**SUBJECT: HARPER'S TERRACE (SUB-13-05)**

I am writing on behalf of JT Smith Companies to request that the application for the Subdivision of Harper's Terrace property (SUB-13-05) be deemed complete upon receipt of this letter. We have prepared this correspondence as well as a revised preliminary development plan set (dated November 21, 2013) and we believe that the revised plans adequately address the comments provided by the City in the October 29, 2013 incompleteness notification letter. We believe that all issues have been satisfactorily resolved within our resubmission to allow for the initiation of the City's formal project review.

The following has been provided to document our responses to each of the requests listed within the City's October 29, 2013 incompleteness notification. Code Sections and Staff comments have been listed to the left and the Applicant's responses have been provided to the right:

SHEET TITLE  
**TREE PLAN**  
SHEET NUMBER  
**C1.2**

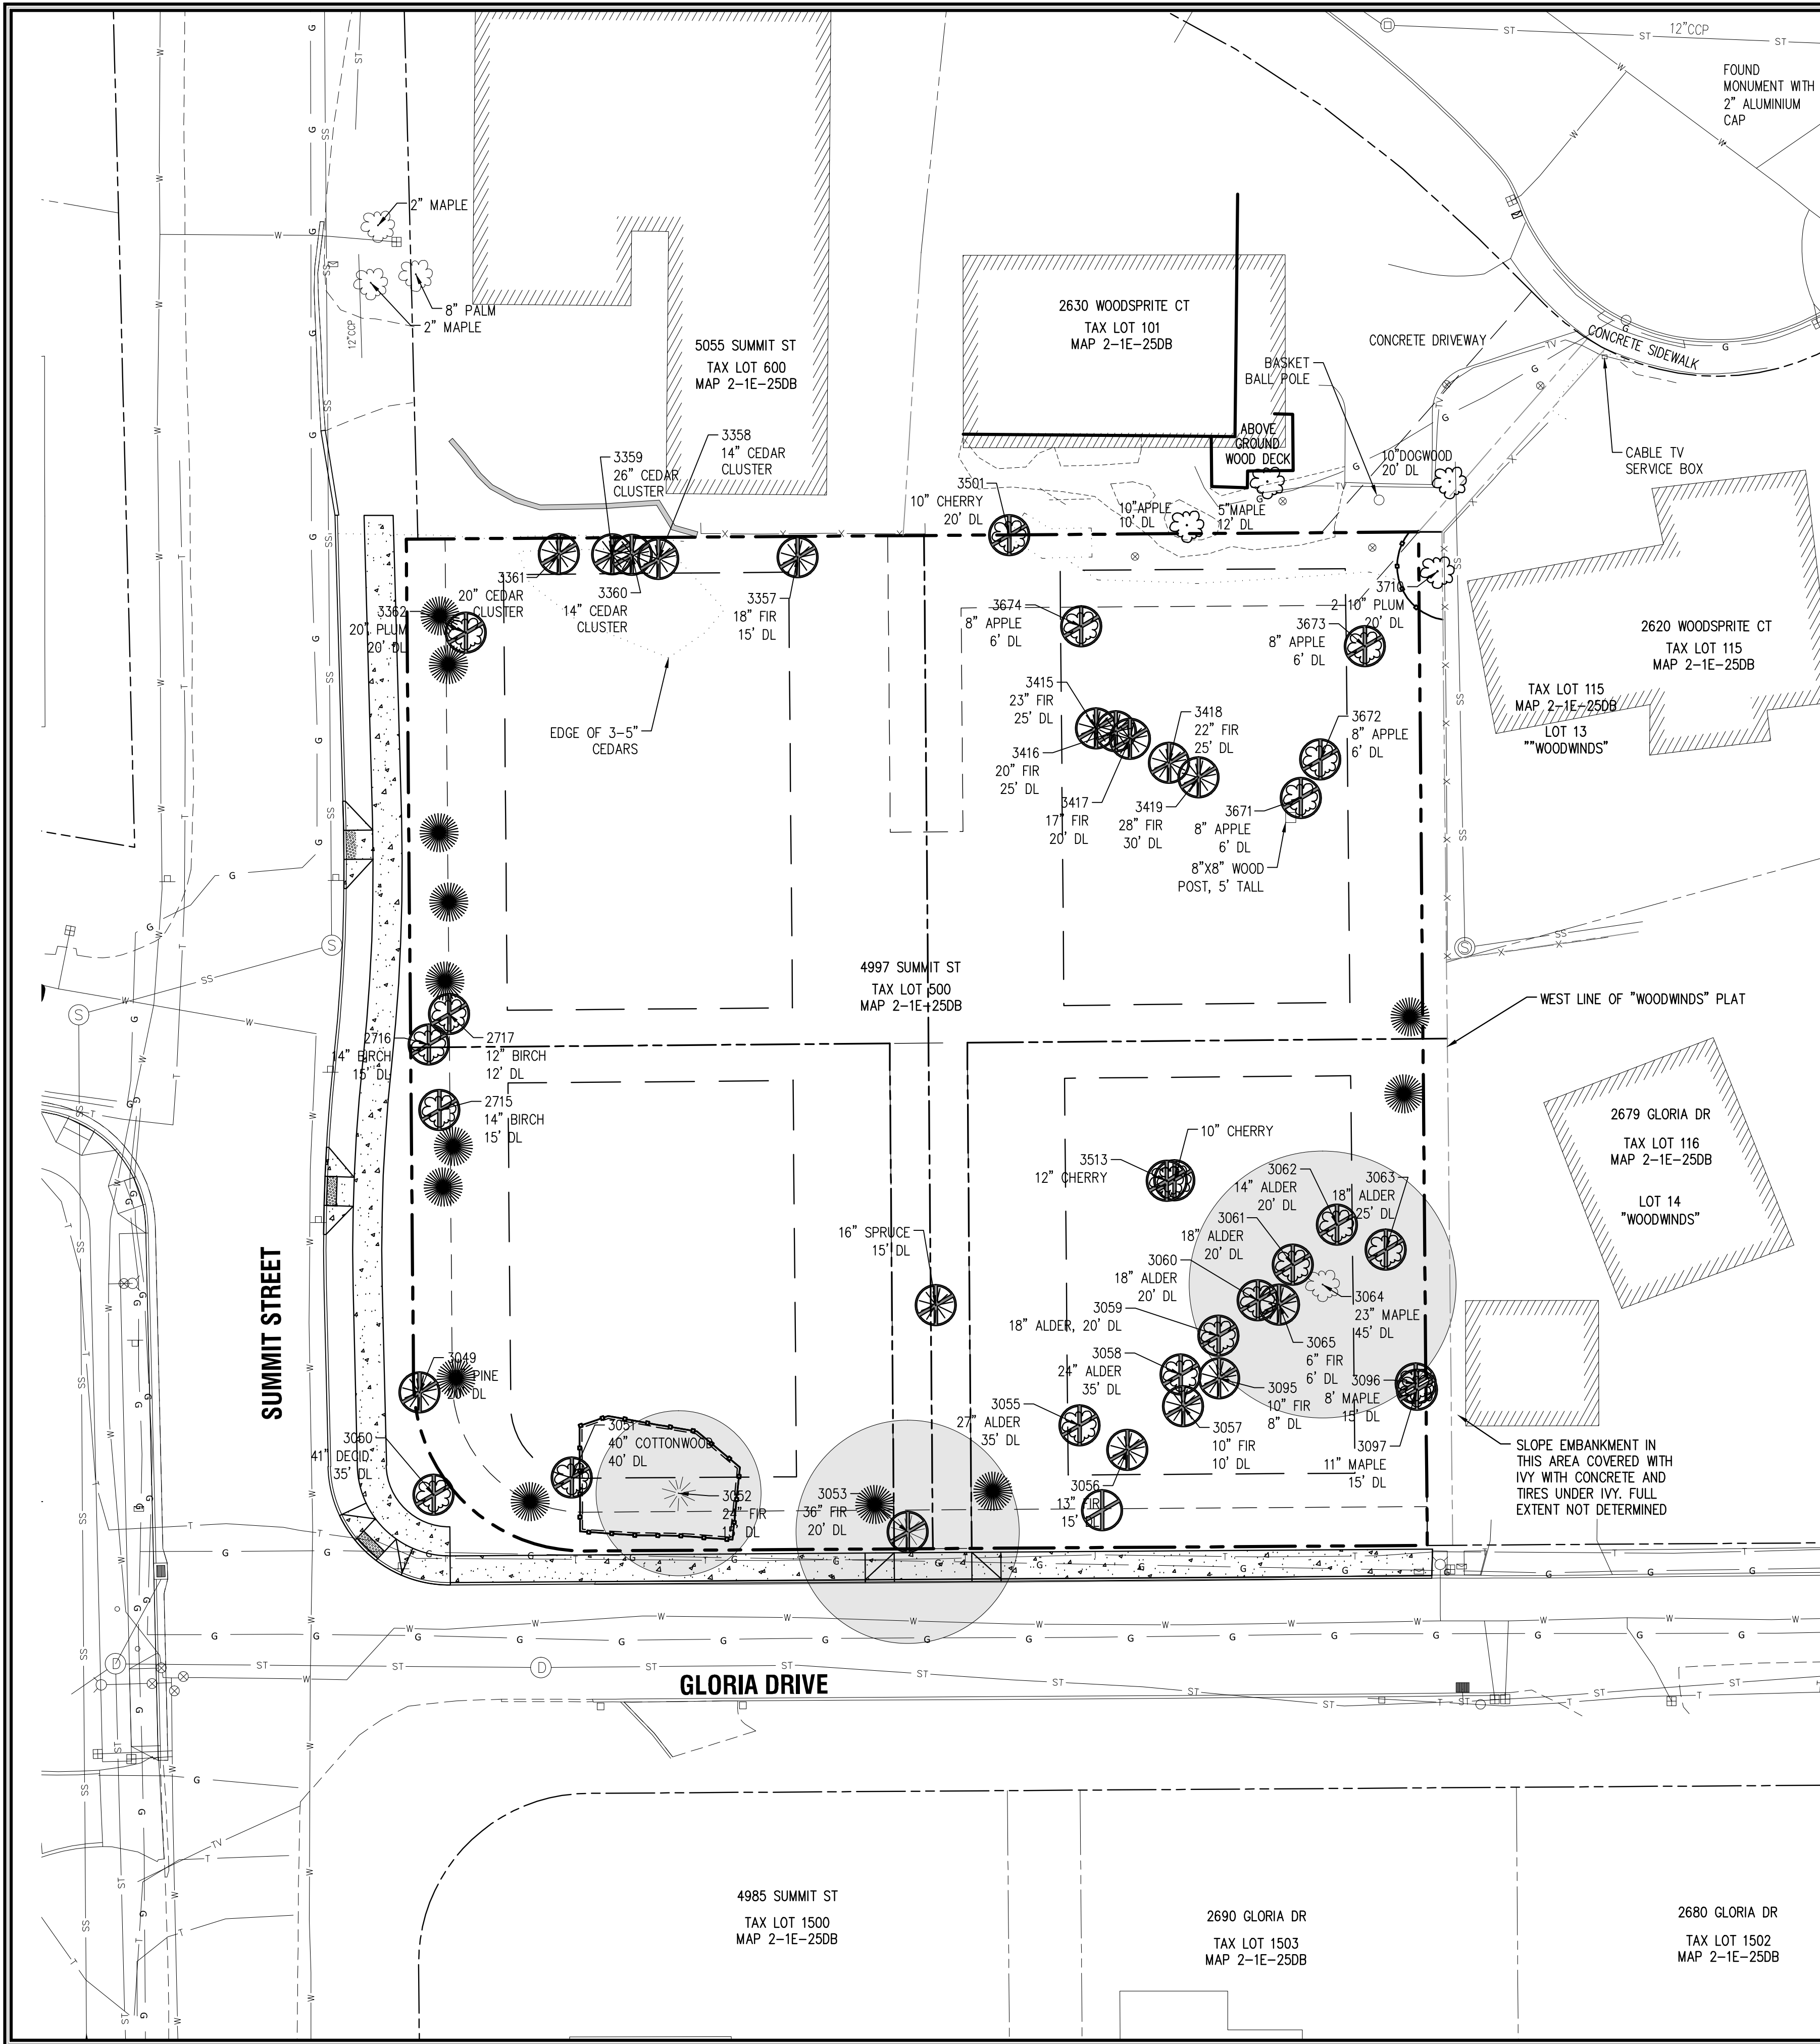
85.160(E)(5)	Show on plans the percentage of Non-Type I and II land that significant tree "dripline +10 feet" areas currently cover, as well as what percentage they would cover after development.	The Applicant has revised the plans to show the requested calculations.

SHEET NUMBER  
**C2.1E**

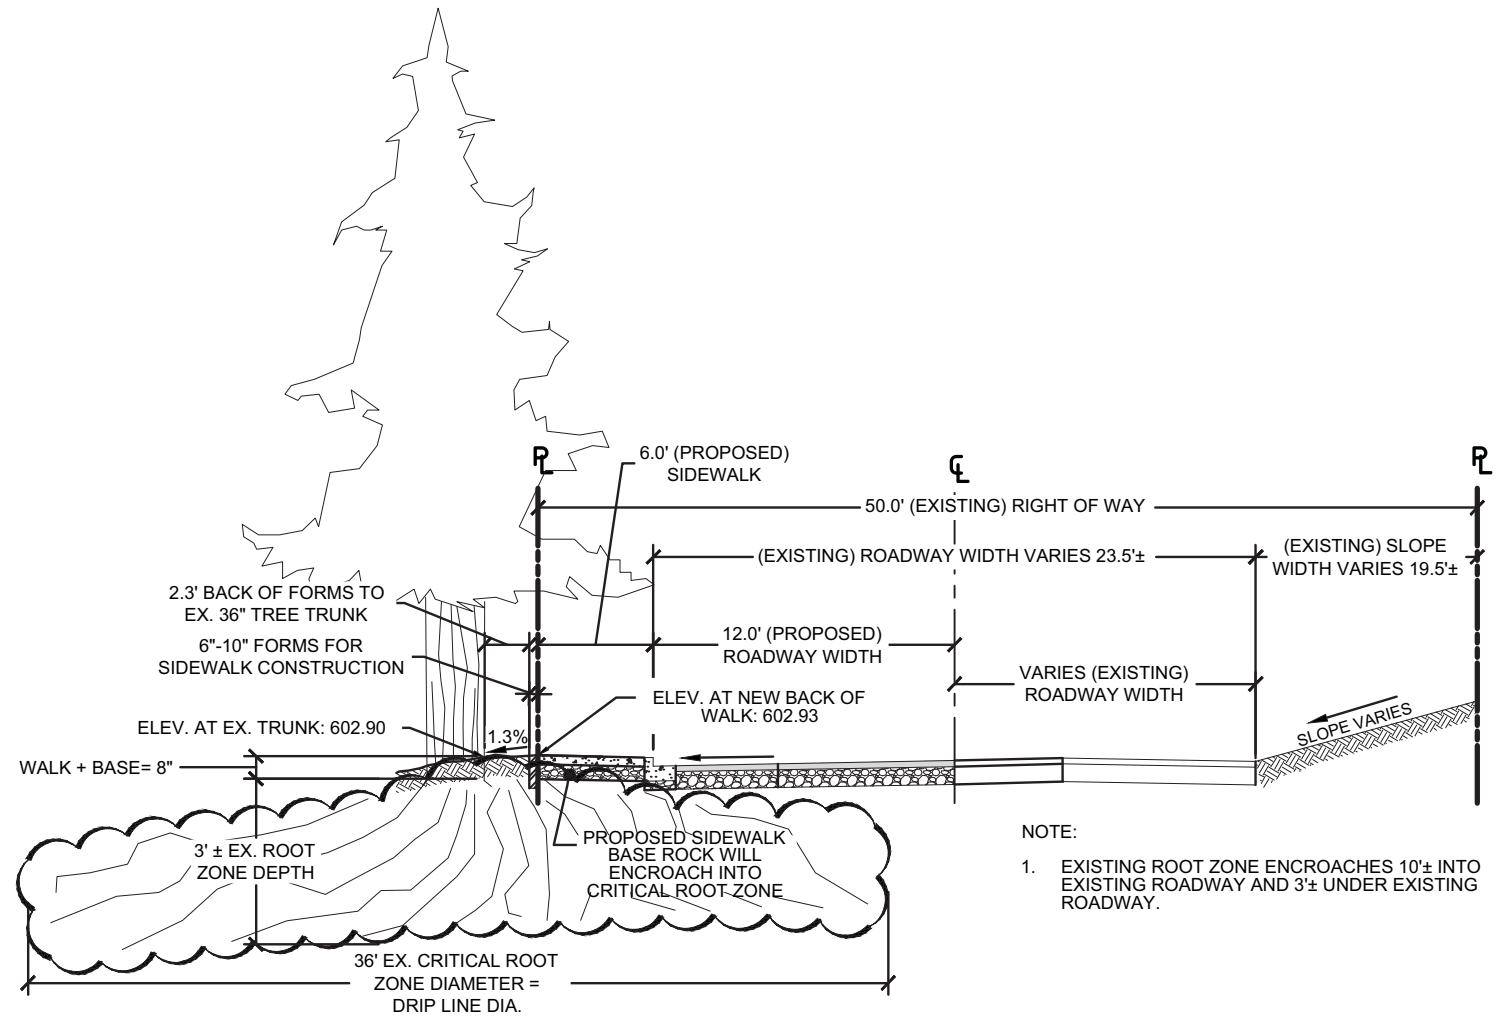
Finally, staff has requested that the applicant consider an access option to the site which would realign the proposed driveway to try to retain a significant fir tree (#3053) which is currently positioned within the center of the access drive. The Applicant has explored the option of realigning the driveway that will provide access to the four lots from Gloria Drive. The Applicant and the Applicant's arborist have concluded that the impacts to the subject tree from the widening of Gloria Drive and the placement of a sidewalk along Gloria will prevent the Applicant from retaining the tree. As such, the realignment of the driveway will not facilitate the desired retention.

The Applicant has submitted an exhibit detailing the impacts to the critical root zone of this tree from the construction of the roadway and the sidewalk. The tree's root zone along the roadway will be subject to significant construction impacts within three feet of the base of this tree and it is considered to be too risky to retain this tree following the construction of Gloria. The Applicant's proposed plan will still be able to comply with the requirements of section 55.100.B.2.f in that a minimum of 20% of the area of significant tree canopy will be retained in easement and trees removed for roadways shall be mitigated for.

**C1.3**

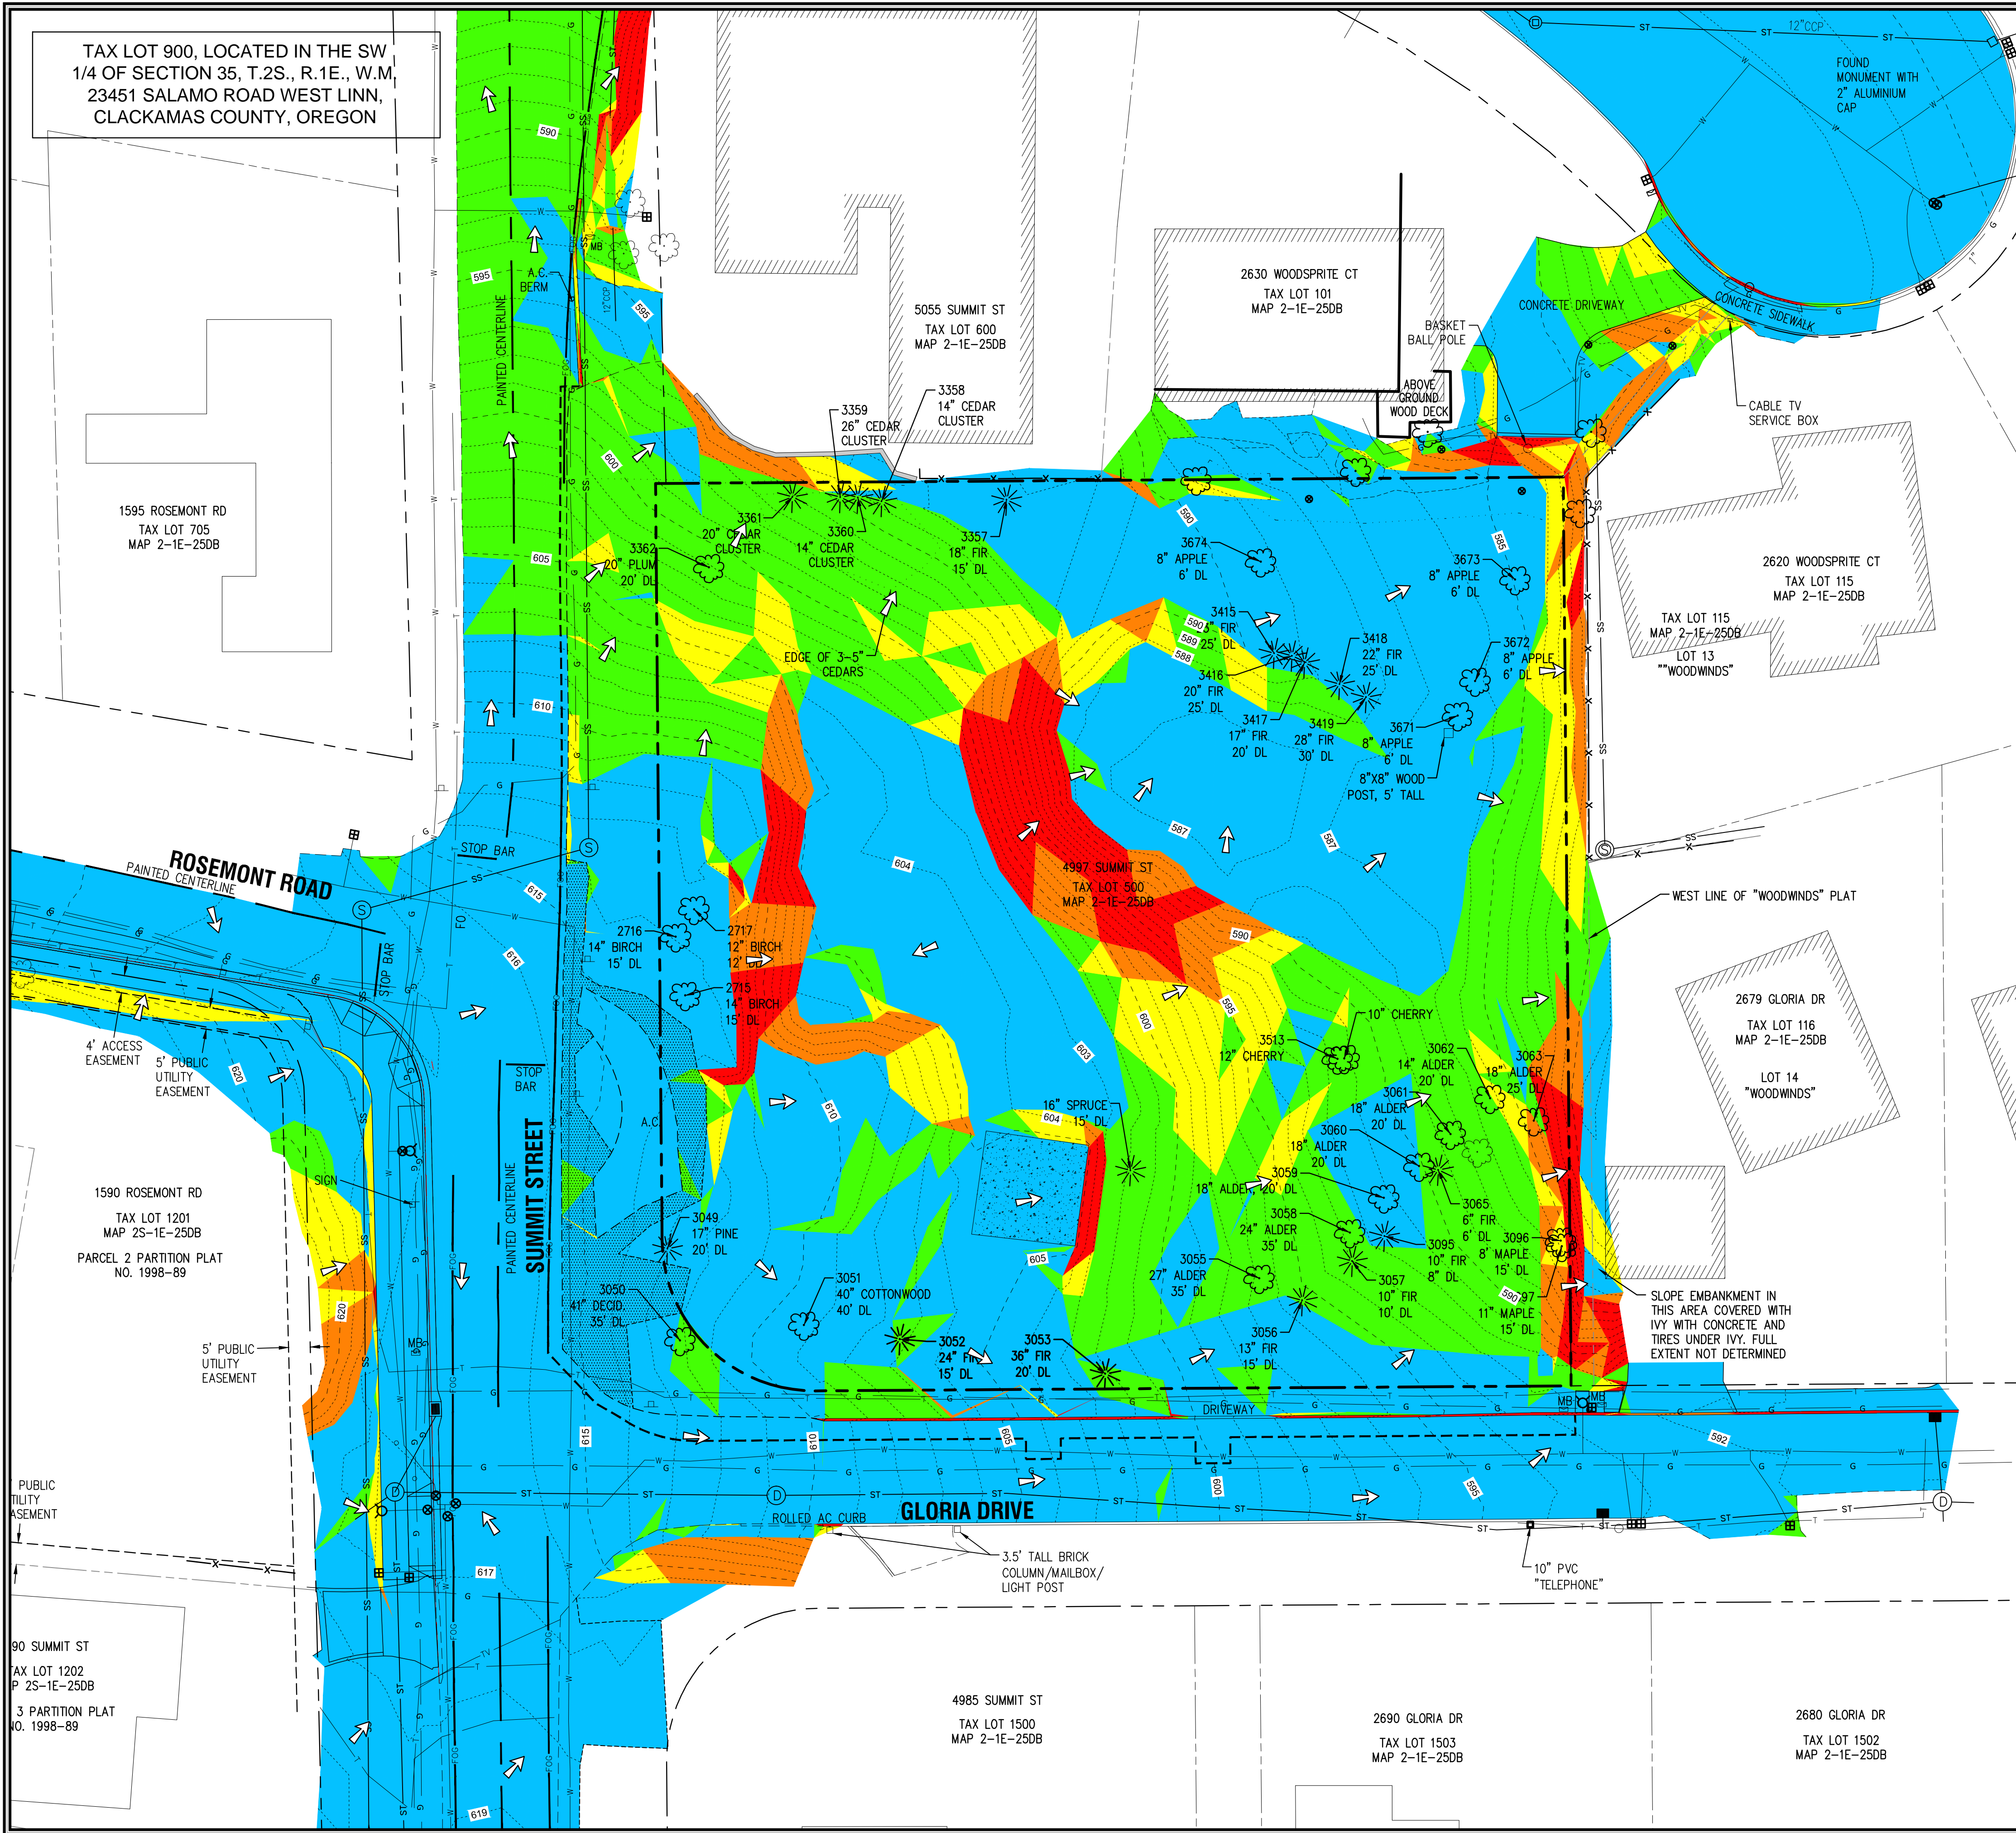
85.170(A)(8)	Show all slope categories from 55.110(B)(3) including (c-e)	The Applicant has revised the Slope Analysis Plan on Sheet C1.3 to include all slope categories from 55.110(B)(3)(c-e)
